PROJECT TITLE
80 E
OLENTANGY
POWELL, OHIO 43065

PROJECT NO. SJM_2010
ISSUE FINAL P&Z APPLICATION
ISSUE DATE 04.21.2021
SHEET TITLE

Gretchen Bonasera is proposing to renovate and expand the current building, converting the existing home to a private social club featuring rare bourbons, fine wines, and chef inspired cocktails with just enough small plates of food served to imbibe responsibly. We anticipate our club to be used as a place to gather for business or social, and to be a great place to come before or after dinner plans at one of the great local restaurants Powell has to offer.

The purpose of this document is to address comments from previous meetings and/or staff reports from the City of Powell Planning Staff, the Historic Downtown Advisory Commission and Liberty Township Fire Dept...

1
G001
ARCHITECTURAL SITE PLAN
1" = 10'-0"

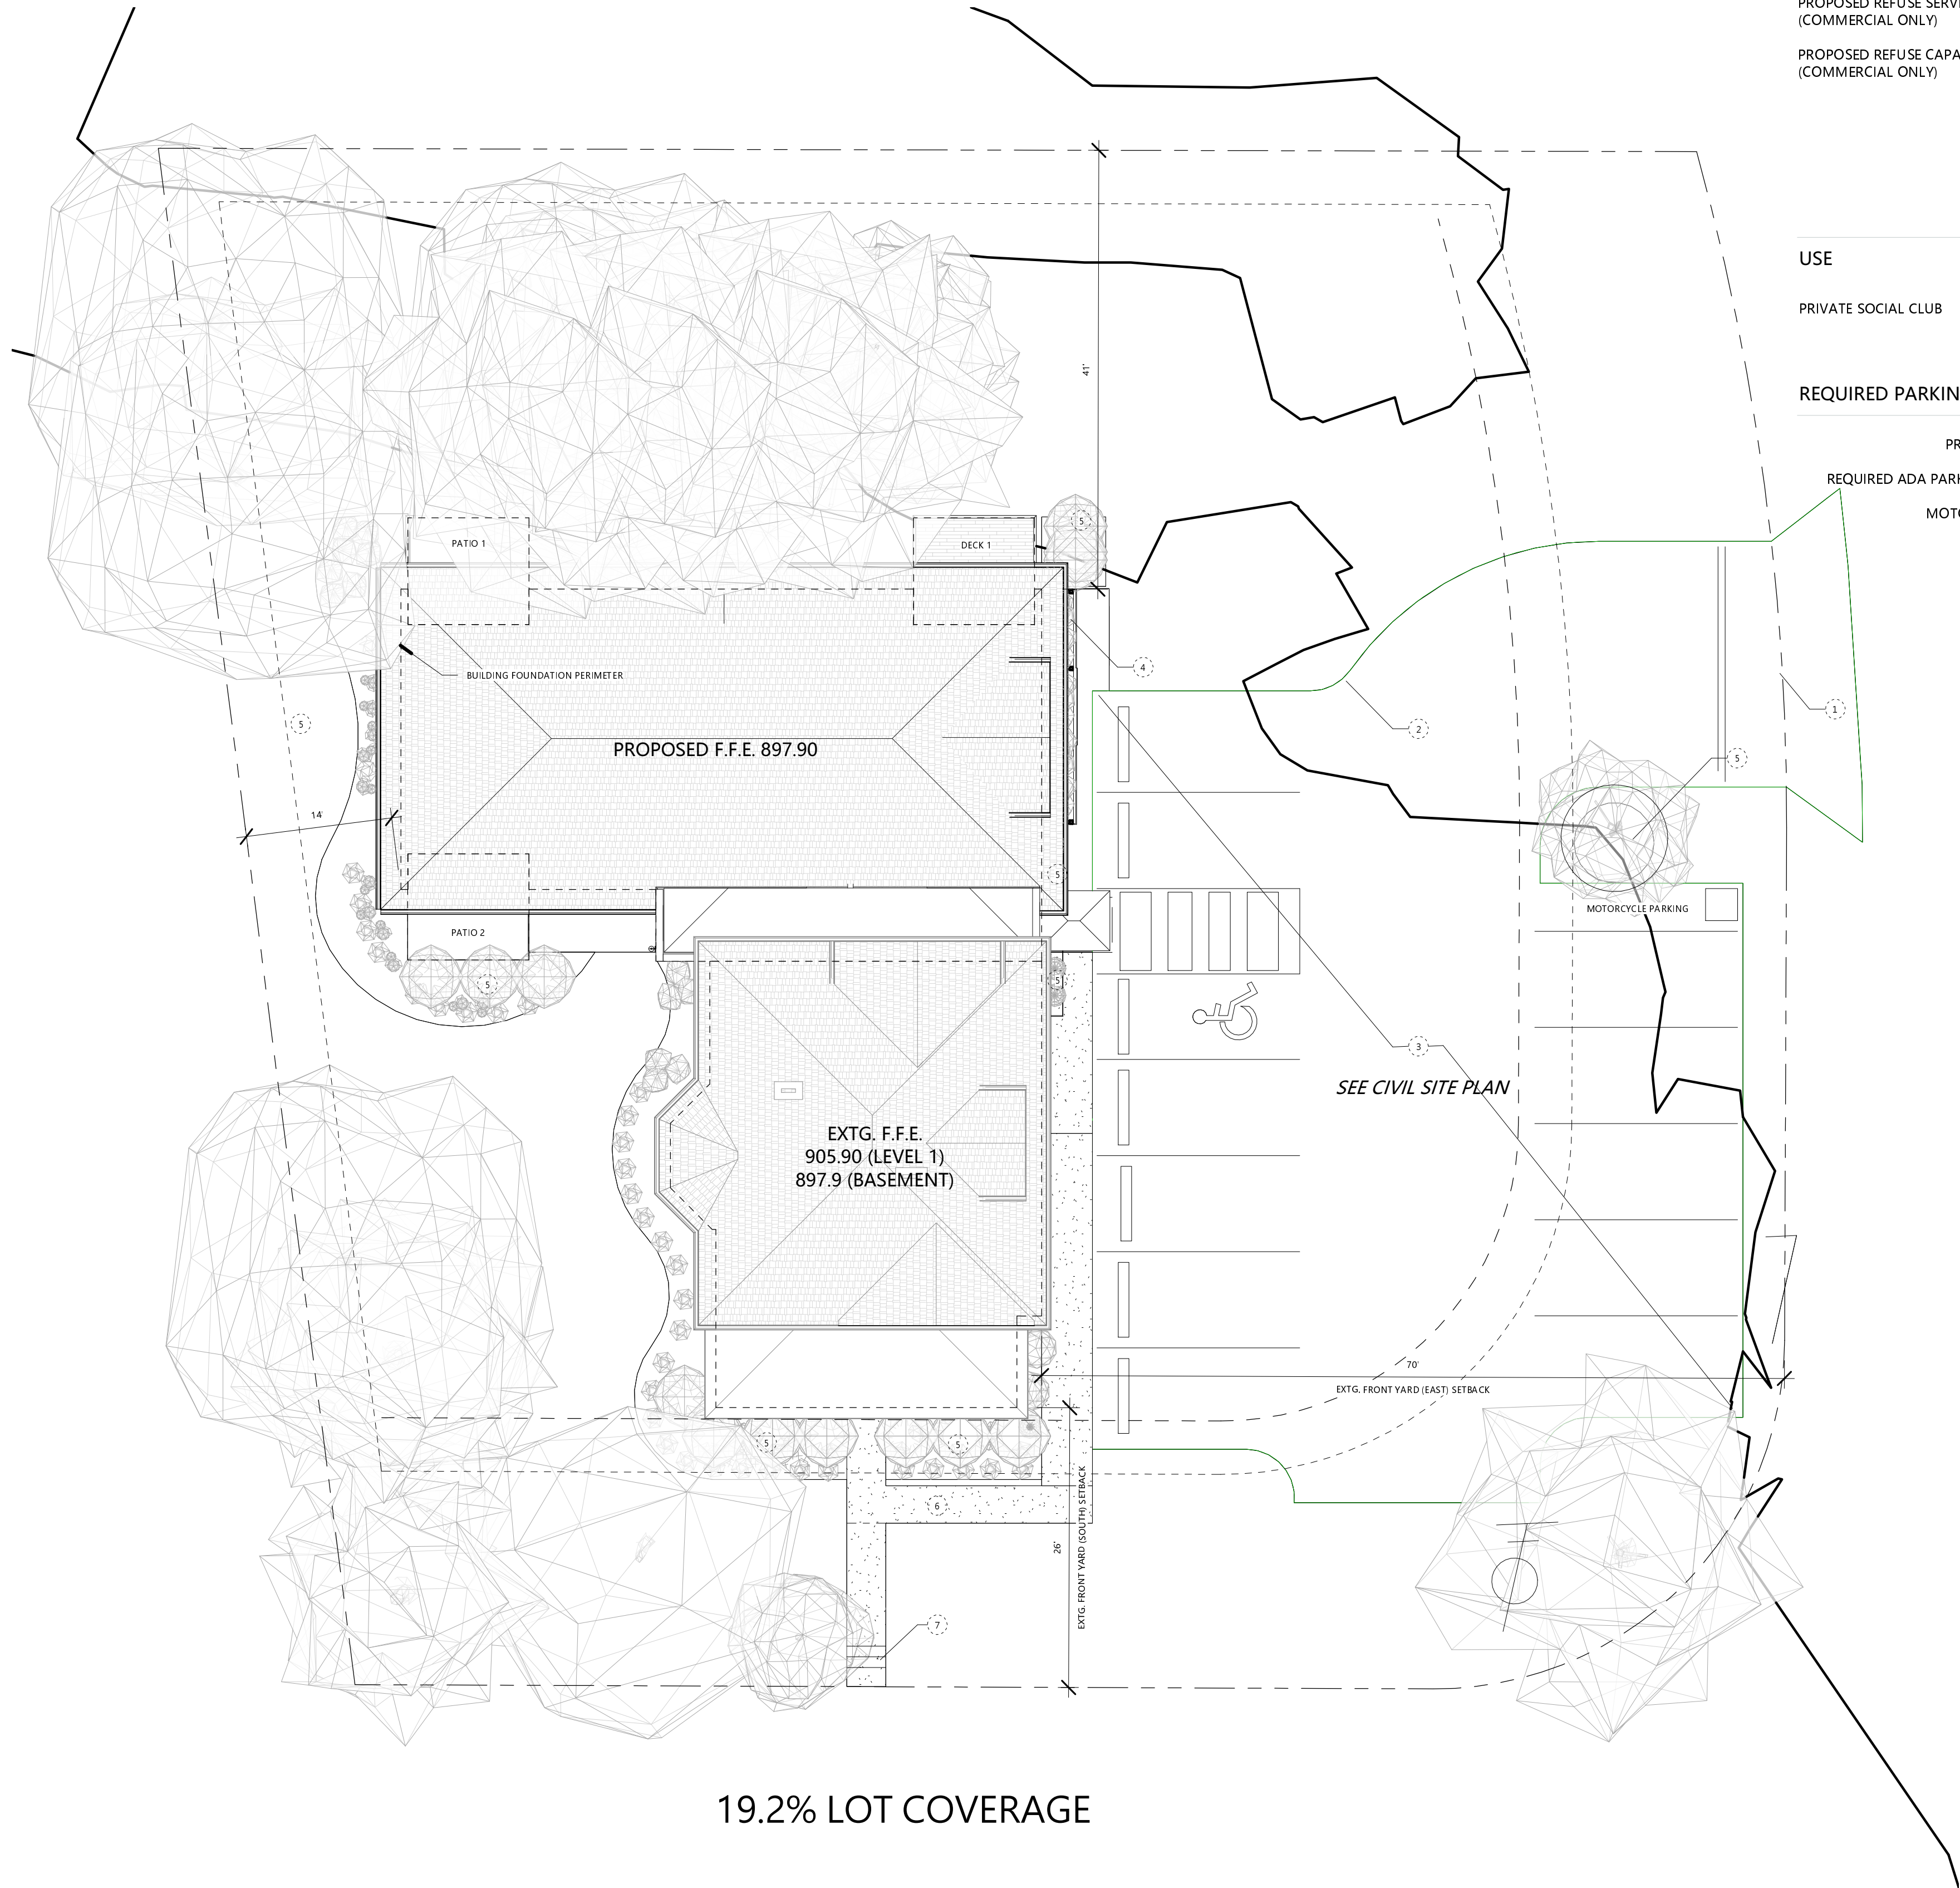
Staff Comment: The access drive is proposed in the least obtrusive location, as it is as far from the Grace Dr/E Olentangy St intersection as possible while maintaining the flood plain from Bartholomew Run. However, staff is concerned that the 24' wide access drive is wider than necessary and requests the applicant work with Staff as well as the Liberty Township Fire Department to decrease the size of the drive, if possible.

Liberty Township Fire Department Comment: Can the proposed concrete island at the drive entrance be removed or constructed with a mountable or soft curb to provide easier access for our ladder truck in the event of an emergency.

Staff Comment: Parking in the rear yard is not an option, as this property is a corner lot with a

HDAC Comment: Concern with getting in and out of Grace drive.

Our Design: *Following conversation(s) with the City Engineer, Chrus Huber, the current site plan represents a "pork chop" installed within the proposed driveway entrance per his recommendation. The "pork chop" will prohibit left turn in and out of the site. The Fire Department has requested access accommodations, thus the proposed curb would be a mountable style. Additionally, signage indicating "No Left Turn" will need to be provided. As a result of these changes, the driveway has been widened beyond the 22' desired width to accommodate turning maneuverability while still maintaining the smallest drive width possible due to site constraints.*

Our Design: *We would propose a mountable curb solution if the "pork chop" curb is required by the City Engineer and planning staff.*

Our Design: *The parking plan was taken almost directly from the previously approved project for this site. The current design is asphalt, but we are looking into if pervious pavers would fit in the budget.*

Our Design: *We are following the same parking lot design as was previously approved and have worked with the City Engineer to come up with the current plan. The new drive entrance is located as far north on the site as is technically feasible and will allow room for (3) cars to be waiting at the light without blocking the drive.*
